Notice of Specification Change for Display Mounting Systems “DKB-Series”

Applicable Products:

Before	After
Material	AC4C	Aluminum Die Cast
Appearance (Clamp)		
Appearance (Keyboard Holder)

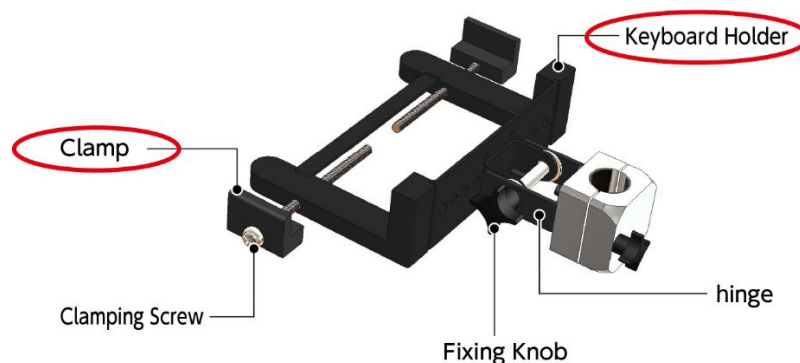
Due to a review of the manufacturing process, the material of the keyboard holder and clamp will be changed.

Optimization of molding conditions has resulted in a slight change to the draft angle, causing minor differences in appearance.

However, this change does not affect the product’s function or performance.
